Access Compliance Report

Public Rights-of-Way

Intersection ID: 27468	Main Street: BALLANTYNE COMMONS PY	Cross Street: JOHN J DELANEY DR	Location: NW
ADA ID: C833C2F6567D	Ramp Type: Perp	Initial Pass/Fail: Fail	Overall Compliance: No
Severity Score: 12.5			
Codes/Mitigation Info/Possible Solution		Field Measurements/Component Compliance

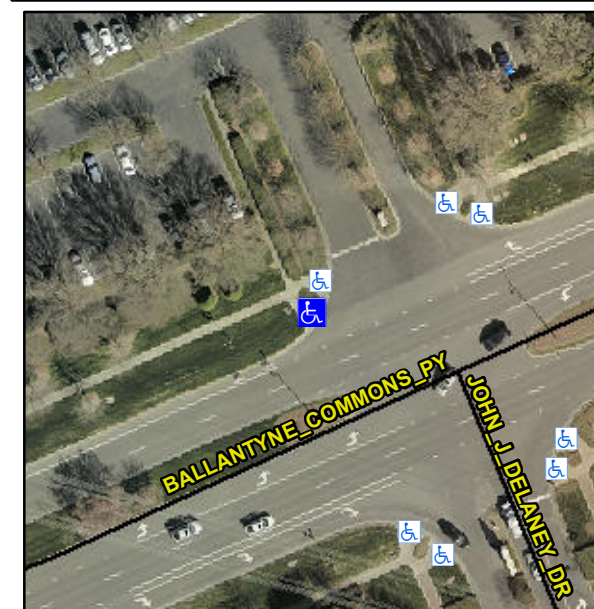
Not Found, R304.5.3

Remove & Replace Entire Ramp.
